FEBRUARY 2020

PL6

NON MATERIAL  
AMENDMENT  
PLANNING  
APPLICATION  
& CONDITION 4  
DISCHARGE

44 A GLOUCESTER  
AVENUE LONDON  
NW1 8JD

173\_PL-COND\_04D\_04\_REV P  
PROPOSED LIGHTWELL STAIRCASE

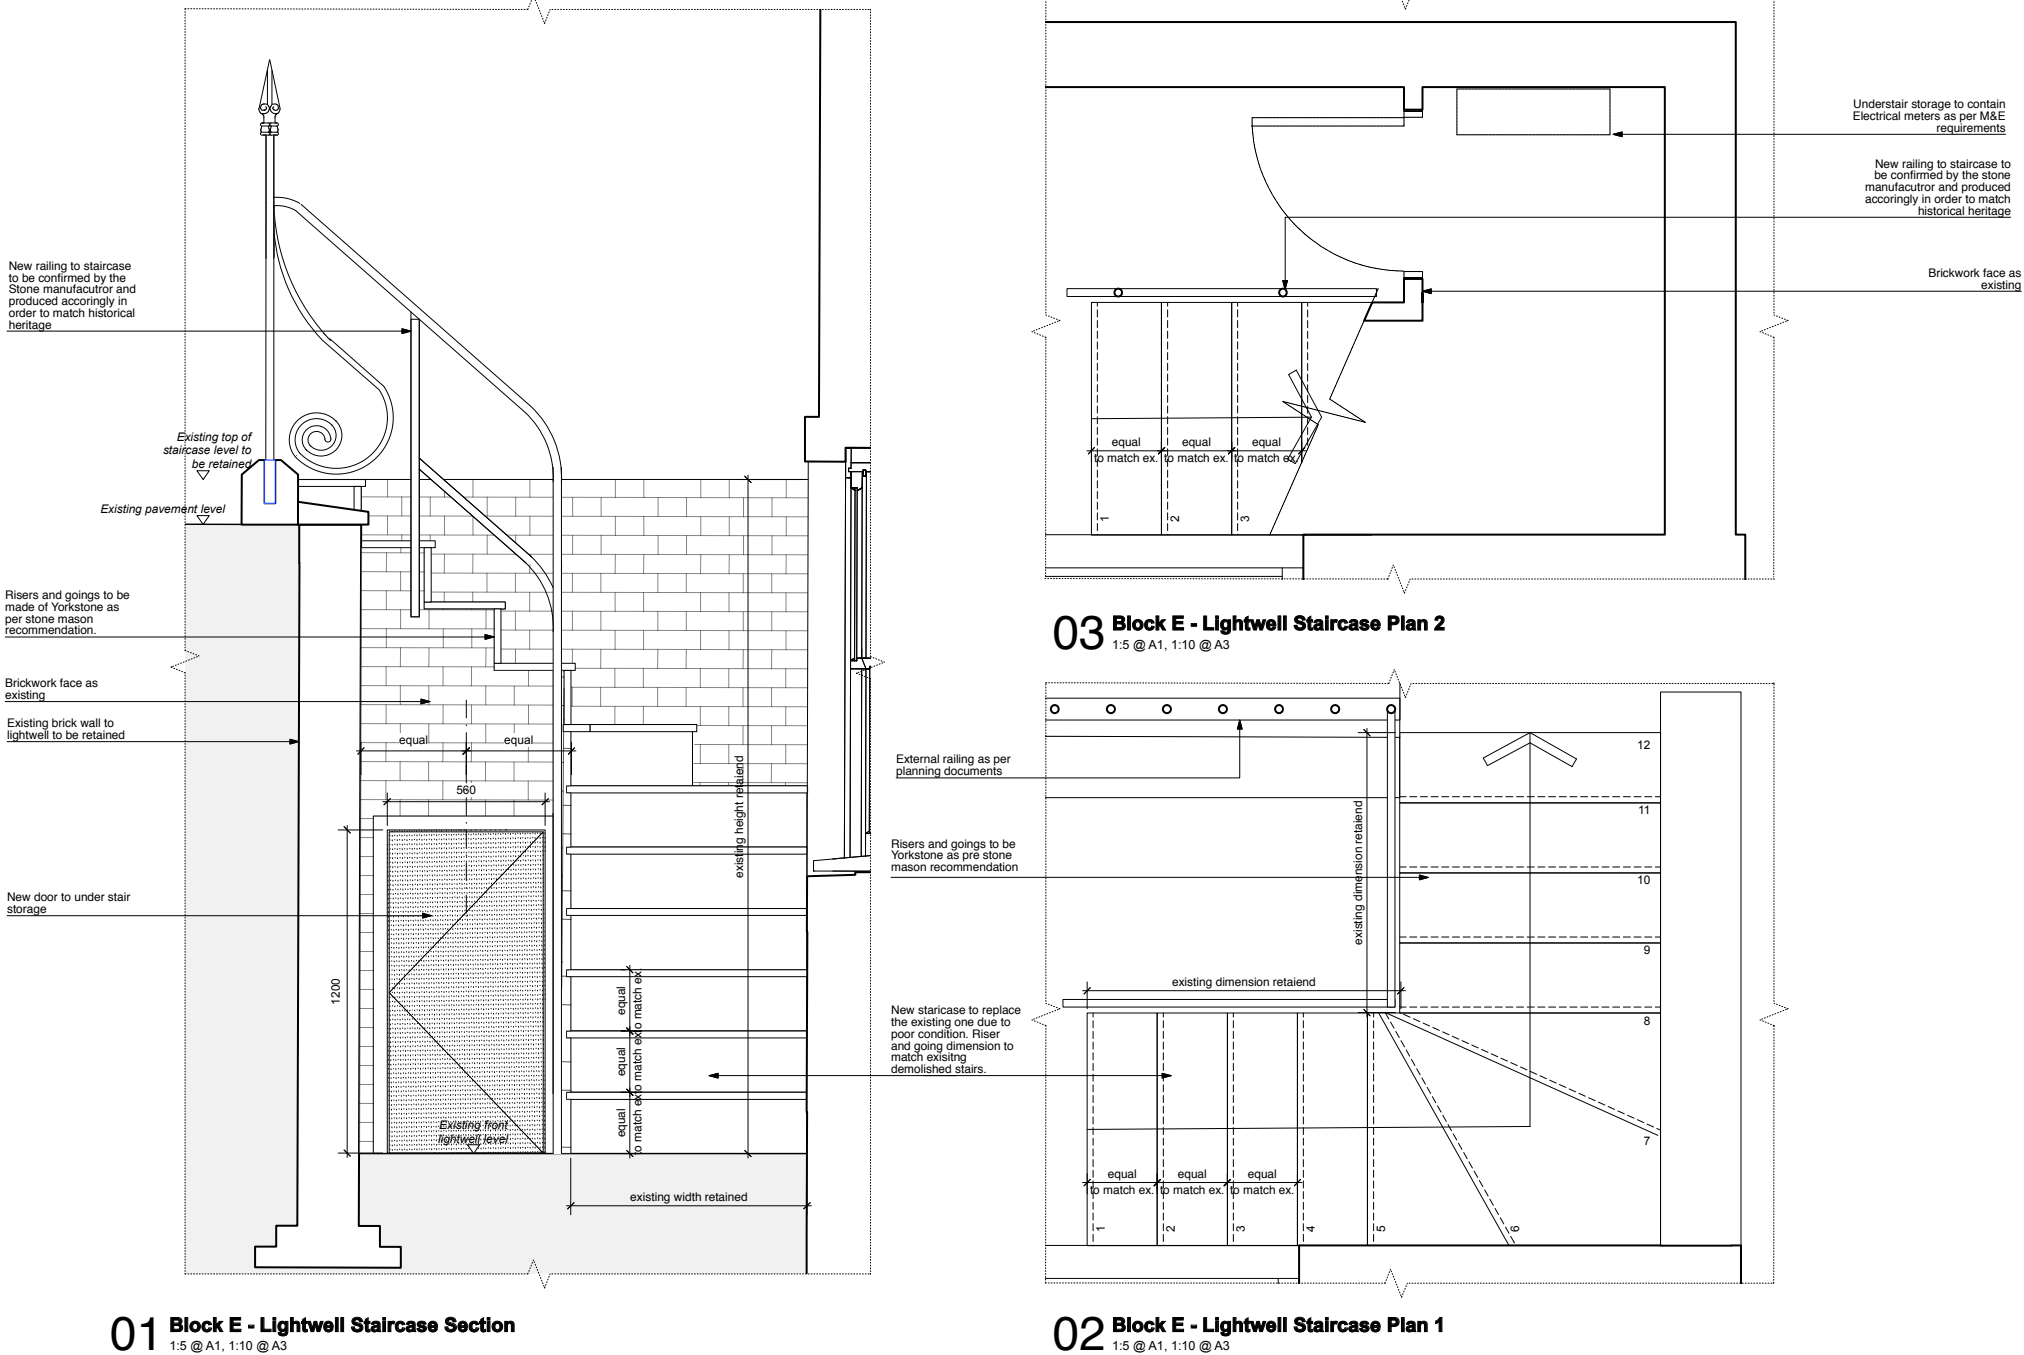
- Existing staircase to be replaced and Yorkstone pavers to be introduced to match original design.
  - "Barcode" design to glassbox to match the design rest of the development

- 1.47 Front balcony existing external staircase is in poor condition and as per Structural Engineers requirements, requires to be demolished and replaced. Original design is to be preserved with implementing the Yorkstone to maintain historical accuracy.
